Errata Sheet

Product Family: C-more Micro-Graphic Touch Panels

Manual Number EA1-MG-USER-M

Revision and Date 2nd Ed, Rev C, 6 / 2013

EA-COMCON-3A

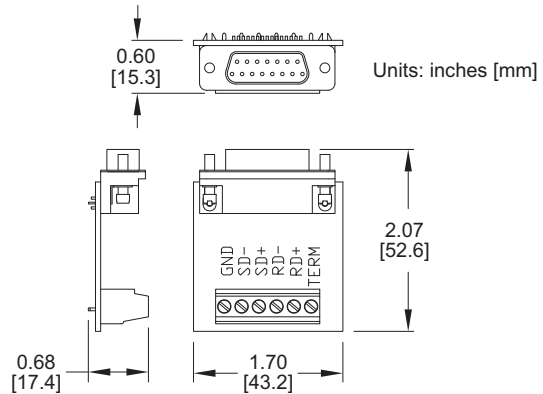
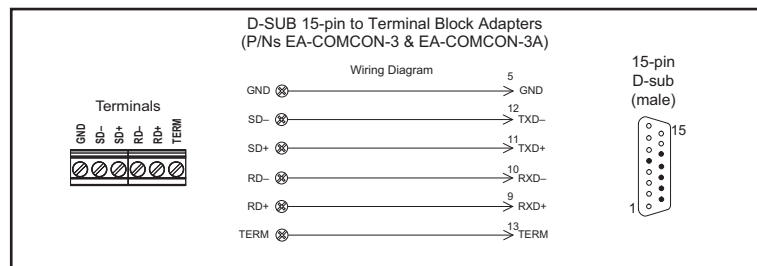
Added EA-COMCON-3A:

Added EA-COMCON-3A to Chapter 3 - Accessories. Additional page follows...

The EA-COMCON-3A adapter may be used with EA-MG-SP1 to provide wire terminal connections for RS-422/485 PLC communication cable. Note that similar part number EA-COMCON-3 will not fit EA-MG-SP1
